## Hydraulic Lift O-Matic Cable Improvement

KA ID : KA000005114

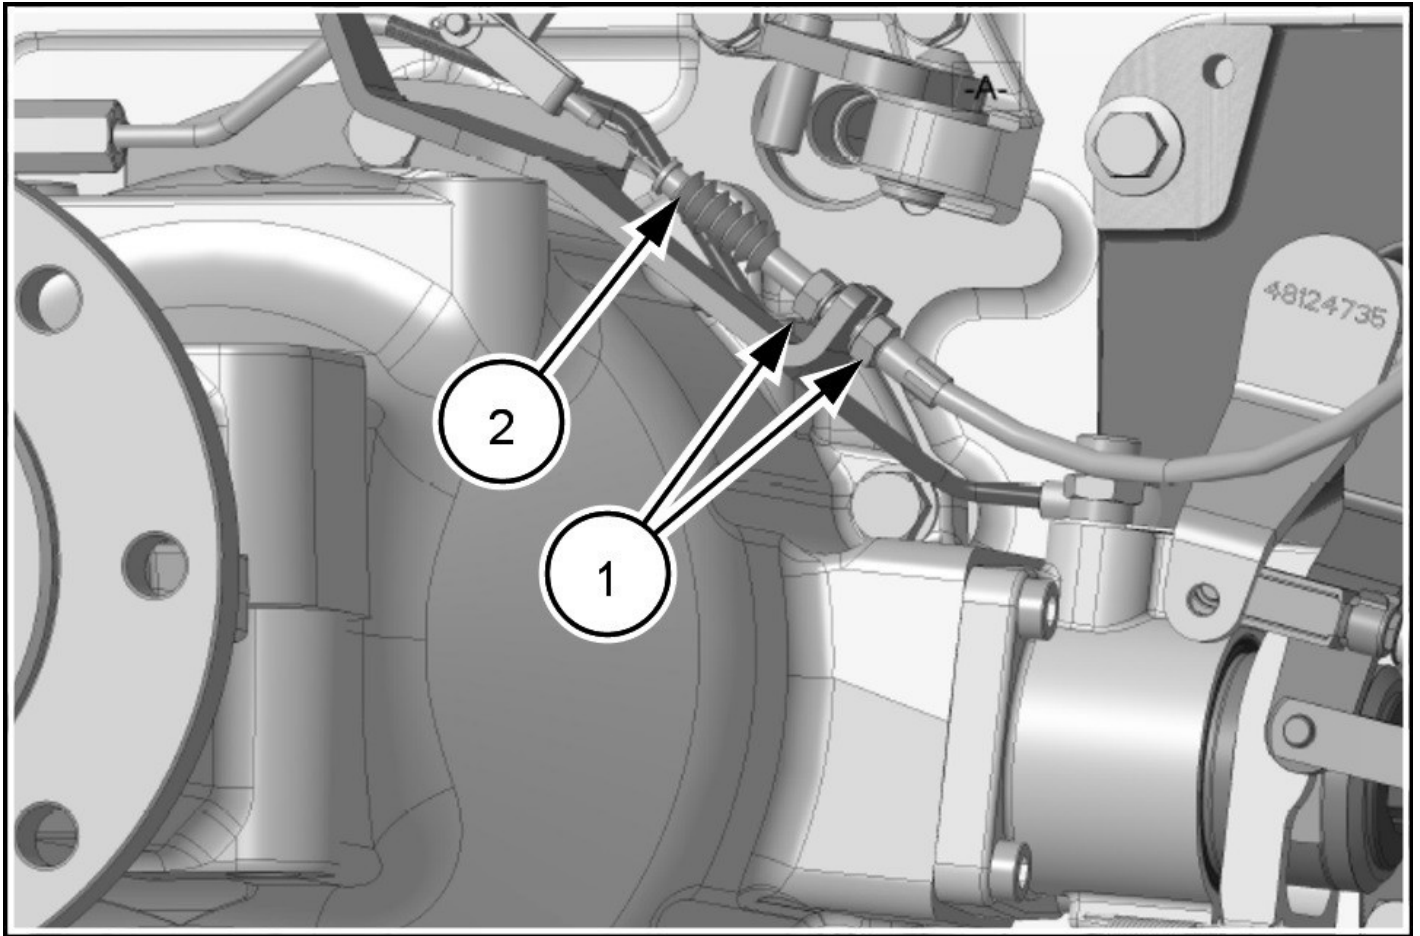
The hydraulic lift arms are not going down, or they are moving slowly.

Loosening nut on the Lift-O-Matic cable (part number: 47815352).

To adjust the **Lift-O-Matic™** lift speed, loosen the spiral nut **(1)** , pull the spiral **(2)** forward and torque the nut with 10 **Nm**.

Lock washers have been added to the cable.

New cable part number: 51678709. The new cable is retrofittable for the field.
